**Comment Form — SAR for Permanent Changes to the Timing Table in Coordinate Interchange Standards (Project 2007-14)**

An Urgent Action SAR to modify the Timing Table in some of the Coordinate Interchange standards (INT-005, INT-006, and INT-008) was approved by its ballot pool on March 30, 2007. The Urgent Action SAR made modifications to the timing table so that the reliability assessment period for WECC was lengthened from 5 minutes to 10 minutes for e-tags submitted less than 1 hour and greater than 20 minutes prior to ramp start.

### Timing Requirements for WECC

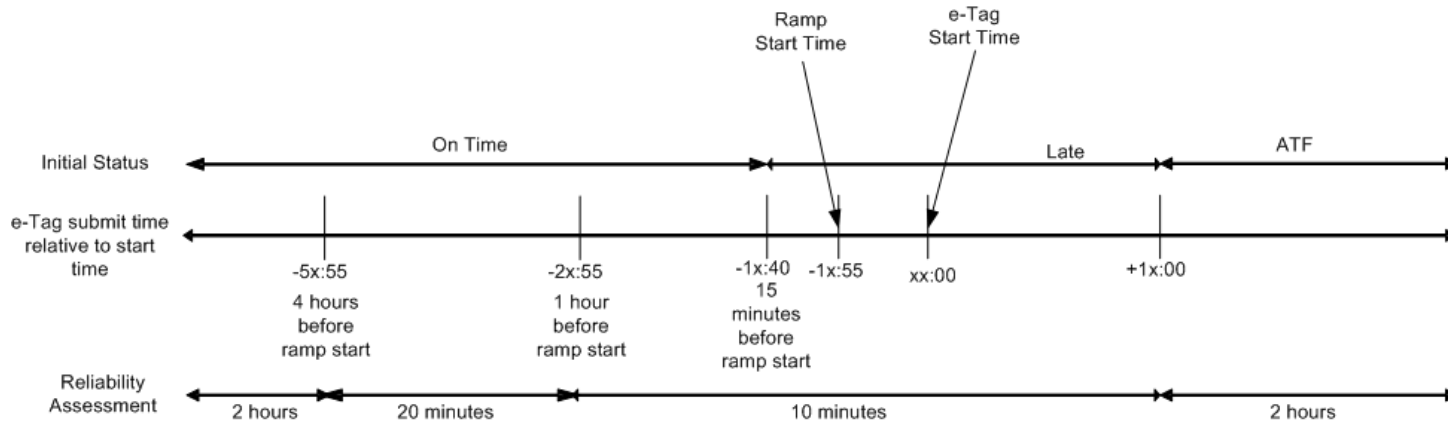
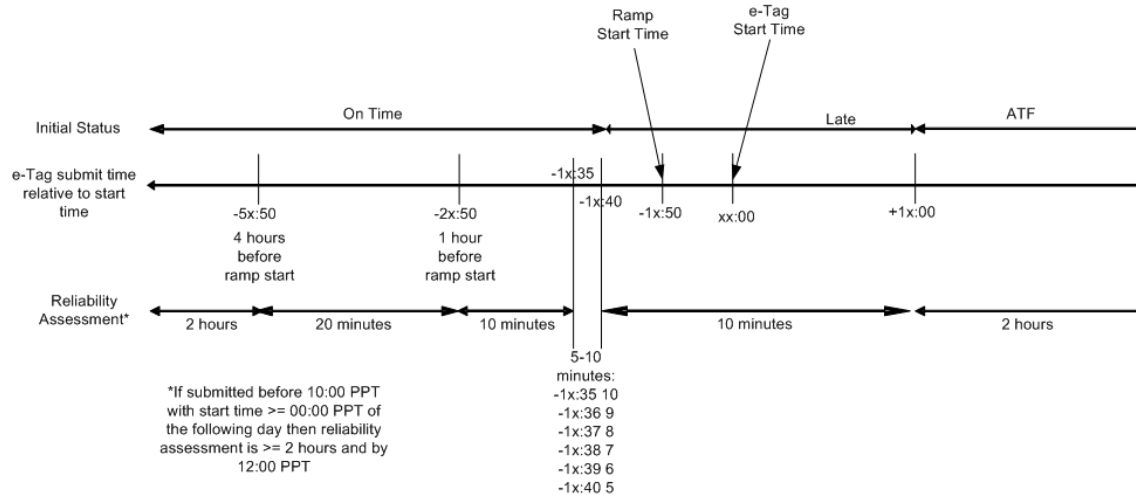
Comments: For this question, please see the attached table. Changes were made to the table at the May 16, 2007 JISWG meeting. The same changes are being submitted to NAESB under Request R07007. JISWG believes the changes made to the table provide clarity for timing requirements. While the majority of changes are formatting in nature, therefore leaving the intent as is, these formatting changes provide a better understanding of the timing requirements.

Comments: For this question, please see the attached table. Changes were made to the table at the May 16, 2007 JISWG meeting. The same changes are being submitted to NAESB under Request R07007. JISWG believes the changes made to the table provide clarity for timing requirements. While the majority of changes are formatting in nature, therefore leaving the intent as is, these formatting changes provide a better understanding of the timing requirements.
